Important announcement for all E-M5 camera owners

Affected Serial Number Range
Black BEJ501001~BEJ504916
Silver BF3501001~BF3503164

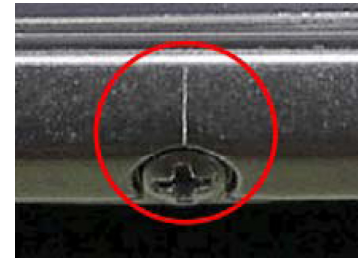
Products affected with defect will have small cracks in the Monitor cover adjacent to the Monitor cover screws at the location shown in the photo.

Inconsistent tightening of screws during the assembly process and inadequate strength of the monitor cover material.

Changes in the manufacturing methods have been adopted. This includes the addition of a washer to more evenly distribute the pressure applied by the monitor cover screws.

The addition of a washer is made to more evenly distribute the pressure applied by the monitor cover screws.
